Access Compliance Report Public Rights-of-Way (RR Crossings)

Intersection ID: 32449	Main Street: N_TRYON_ST	Location: N/A
ADA ID: C9565C38D1A2	Overall Compliance: No	Severity Score: 0.0
Codes/Mitigation Info/Possible Solution		Field Measurements/Component Compliance

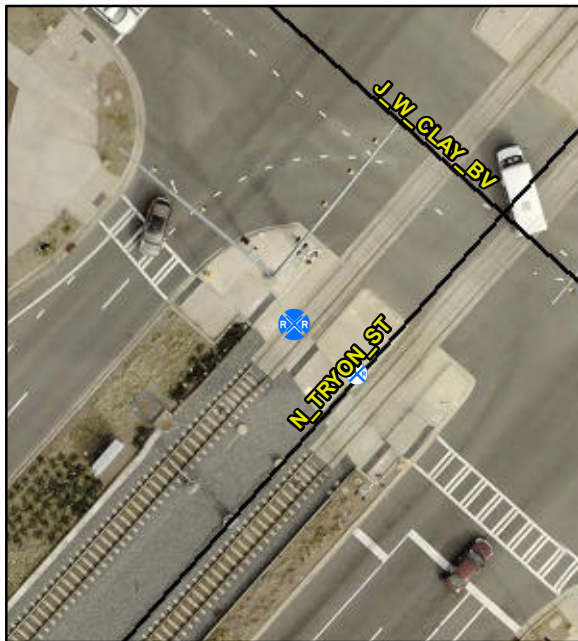
Remove & Replace Detectable Warning System. Provide Pedestrian Gate. Remove & Replace Walking Surface Adjacent to Rail.

Compliance	Description	Data
Yes	DWS Provided?	Yes
Yes	DWS Contrast?	Yes
Yes	DWS Width (in)	Yes
Yes	DWS Length (in)	24.0
Yes	DWS Offset (in)	113.0
No	Pedestrian Gate?	No
N/A	DWS Outside Gate?	No
N/A	Rail Type?	LightRail
No	Flangeway Gap (in)	2.5
Yes	Sidewalk Width (in)	113.0
